TECHNICAL SERVICE BULLETIN

Ting, Pop Or Clicking Noise From The Front Or Rear Wheel Hub When Accelerating Or Applying Brakes (Torque Reversals)

22-2395

Ford
2022-2023 F-150 Lightning

Figure 1

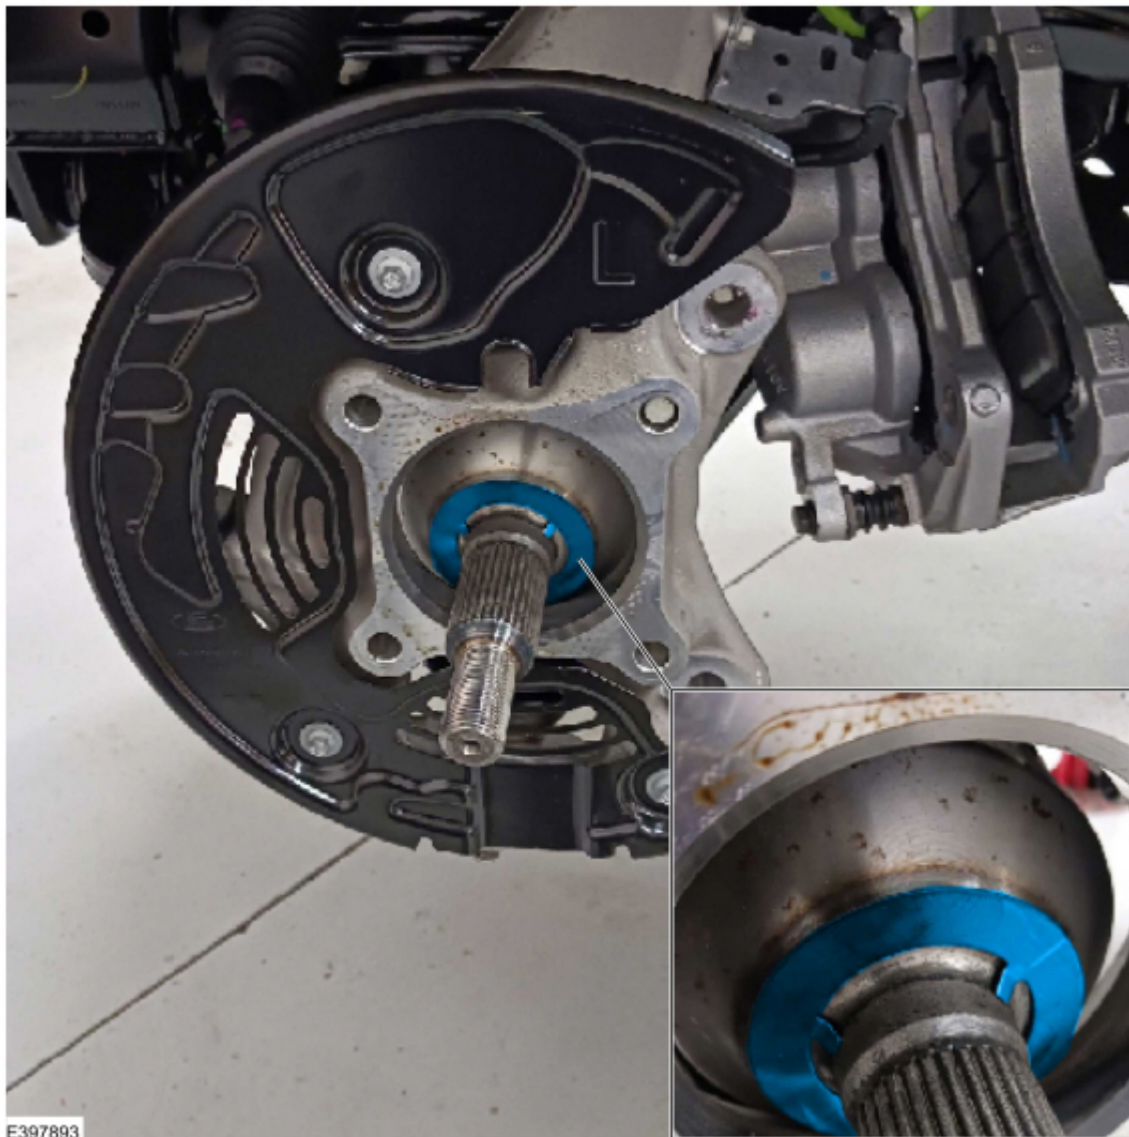
Issue: Some 2022-2023 F-150 Lightning vehicles may exhibit a ting, pop or clicking noise from the front or rear wheel hub when accelerating or applying brakes or when shifting between drive/reverse (torque reversals). This condition may be caused by stick/slip between the hub and halfshaft interface, during the torque reversals creating the ting/pop or clicking noise. To correct the condition, follow the Service Procedure to install the new anti-ting washer between the wheel hub and axle shaft.

1. Drive the vehicle to verify the concern, accelerate/apply brakes or shift from forward to reverse (torque reversals).
2. Does the vehicle exhibit ting, pop or clicking noise from the front or rear?
 - (1). Yes - add the anti-ting washer to both left and right halfshaft to hub interface for front and/or rear of the vehicle that exhibits the noise. (Figure 1) Refer to the Workshop Manual (WSM) 204-02 Rear Suspension - Wheel Bearing and Wheel Hub > Electric Procedure or WSM 204-01B Front Wheel Bearing and Wheel Hub. Install the anti-ting washer between the wheel hub and axle shaft interface and reassemble.
